Rapanui – Shag Rock Cycleway – Puari ki Rapanui

Consultation Feedback and Analysis

Figure 4 Connectivity Concerns

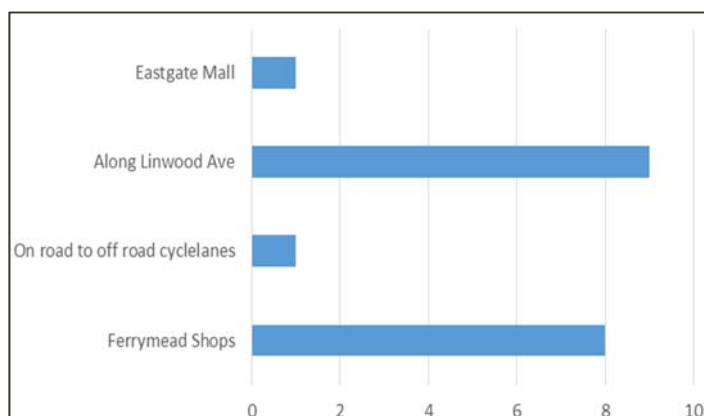
Submissions in support or general support of the MCR sought improved connections with key features along the route. Nineteen submissions (21%) included comments on connectivity with the residential areas along Linwood Avenue.

Submitters sought further detail and consideration of access points to the preferred cycleway on Linwood Avenue to provide safe access for adjoining residents and other cyclists and pedestrians.

Eight submitters (9%) sought improvement of the connectivity with the Ferrymead Shops.

Response: During the Detailed Design phase the local connection to the Linwood Avenue median will be developed, taking into consideration the location and intervals between crossings. This will include the form of kerb build outs and dropped kerbs to shorten the crossing distance and improve visibility. It is anticipated that this treatment may give the perception of narrowing which will reduced traffic speeds.

Crossing upgrades to the Ferrymead shops is within the scope of the Ferrymead Masterplan project and will be incorporated into the Detailed Design as necessary.

Figure 5 Loss of U-Turn Facilities

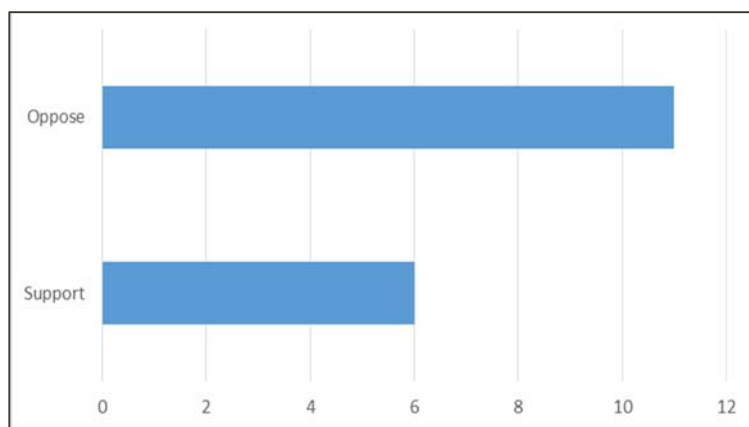
Submitters raised specific concerns with the configuration of the proposed closure of the U-turn near Chelsea St due to its frequent use by students, parents and rugby club members/supporters. Submitters opposed to the loss of U-turns were also concerned with additional travel time required to seek an alternative U-turn. One alternative suggested bridges over the U-turns for cyclists.

Submitters sought further analysis of the impacts of the closures on traffic flow and school drop off / collection times.

In addition to above, 17 submissions in support of the MCR were opposed to the crossing priority at the U-turns, where cyclists are required to give way to vehicles. One submission noted that having raised platforms *and* a requirement to give way to vehicles was contradictory.

Response: The closure of three U-turns provides a significant safety benefit by reducing the cyclist / vehicle conflict. The priority between cyclists and vehicles at the U-turn crossings has been further investigated, including external auditors. For safety reasons, the decision is to retain vehicle priority at these locations. Cyclist grade separation is costly and uncomfortable due to the gradients for the cyclists and is therefore not feasible.

The detours required as a result of the closures are minimal and the U turns for closure were chosen based on very low traffic volumes. Ideally all U turns would be closed, however the network impacts were considered too significant.

The concerns raised regarding the Chelsea Street U turn will be mitigated by extending the scope of the project to upgrade the alternative Cranley Street U turn which will require a detour of approximately 240m.

The Chelsea Street signalised crossing will be upgraded to reduce the safety risk of cars queuing across the pedestrian/cycle area with no stopping hatching which will be beneficial to pupils at Linwood Primary School.

Figure 6 Retention of Existing on-road cycle lanes

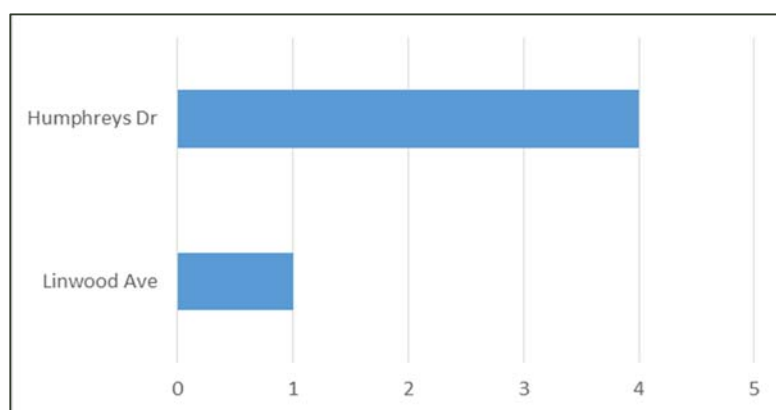
A number of submitters commented on the existing on-road cycle paths. Submitters in support of the proposed scheme sought the retention of the on-road lanes for faster and / or more experienced riders along the Humphreys Road and Linwood Avenue sections.

One submitter was concerned with the existing on-road cycle lane at Hargood Street which requires cyclists to merge and manoeuvre through traffic.

Response: During Detailed Design further investigation will be carried out to assess the cost impact of retaining on road cycle lanes on both sides of the road for the entire route (particularly along the seawall rebuild and over the Linwood Canal Bridge, where the cost will be most significant) as it is recognised as a desirable outcome.

The existing on-road cycle lane at Hargood Street, which requires cyclists to merge and manoeuvre through traffic will be upgraded to provide on-road cyclists a continuous level of protection from traffic.

Figure 7 Comments on Crossing Designs & Signal Details

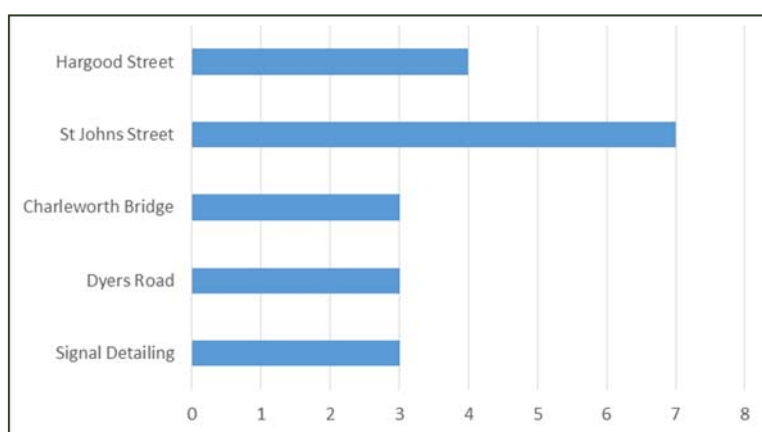
Four submissions recommended including cycle signals at the Hargood Street intersection crossing east to west on the south

side of the road, for those that want to travel via the drain pathway and not via Linwood Ave.

Seven submissions were received on the proposed alignment at St Johns Street. One submitter noted that the proposed layout was convoluted and would be more effective if straightened. Submissions questioned the setback of the crossing from St Johns Street and recommended shifting the crossing to improve alignments and/ or access.

A recommendation was also made that the signalised crossing (near the windsurfers reserve) be aligned 30m west of where it is proposed as it will then be aligned with the Charlesworth Bridge, making more convenient crossings into the reserve and coastal pathway.

Three submissions referred to the Dyers Road intersection, with concerns about the crossing design, safety and delays. General comments in regards to the signalised intersections, included shorter cycle times, so cyclists don't have to wait so long and advanced signal detectors.

Response: Developing the MCR along the Linwood Drain from Hargood Street to the west is not considered as it may prove confusing in terms of connectivity with the wider network. Therefore the cycle crossing will only provide access to the Linwood Avenue median to the west. Cyclist or traffic priority at U- turns is still under investigation and will focus on the optimal safety outcome.

The offset alignment of the refuge at St Johns Street was designed to reduce conflicts between cyclists and turning traffic, however this will be re-considered during Detailed Design due to the submissions.

Direct alignment with Charlesworth Bridge has not been provided due to the Linwood paddock access on the north side at this location.

A separate cycle crossing is proposed on the south side of Dyers Road intersection. Cyclist priority at traffic signals through phasing arrangements and advance detectors is a standard approach on a major cycleway, the details of which will be incorporated into the signal design during detailed design.
